# UNITED STATES PATENT AND TRADEMARK OFFICE

APPLICATION NO.	FILING DATE	FIRST NAMED INVENTOR	ATTORNEY DOCKET NO.	CONFIRMATION NO.
10/803,399	03/18/2004	Stephan K. Barsun	200313138-1	5524

<b>Office Action Summary</b>	<b>Application No.</b>	<b>Applicant(s)</b>	
	10/803,399	BARSUN ET AL.	
	<b>Examiner</b>	<b>Art Unit</b>	
	Zachary M. Pape	2835

Fig 1a

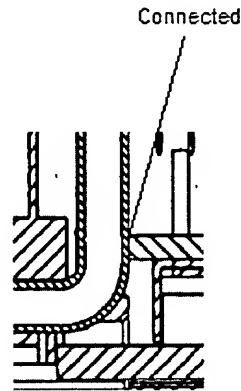
With respect to claim 4, the claim recites, "the second base is configured to conduct heat from the central processing unit to the second array of fins without conducting heat to the first base" however as illustrated in Fig 5, the heat pipe (102)

which is thermally connected to the second base appears to be thermally connected to the first base (90) as well (See Figs 1a, and 1b below). Thus the recitation, “without conducting heat to the first base” appears to be incorrect.
